Technical Update (November 2003)
Astro and Zenith
New 001 & 002 chiller, syrup pump couplings.

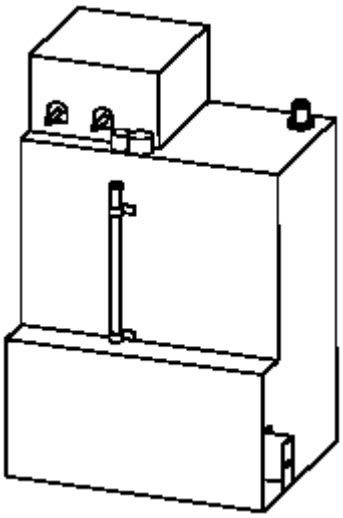
A condition relating to the syrup pump outlet couplings used on NEW001 (2-flavour carbonator) and NEW002 (2-flavour chiller) units has been identified.
Irregularities in the mating face of the syrup pump flow regulator have led to a number of push-fit coupling failures resulting in syrup product leaks within the carbonator / chiller unit.

All NEW00x units are fitted with an alternative stainless steel coupling.

We recommend that field based units purchased before 11th August 2003 are retrofitted with the alternative part.

A retrofit kit containing instructions and sufficient parts for 1 syrup pump has been released, you will therefore require 2 kits per machine.

A retro fit kit is available without charge, currently under Booth Part No "1A4038."
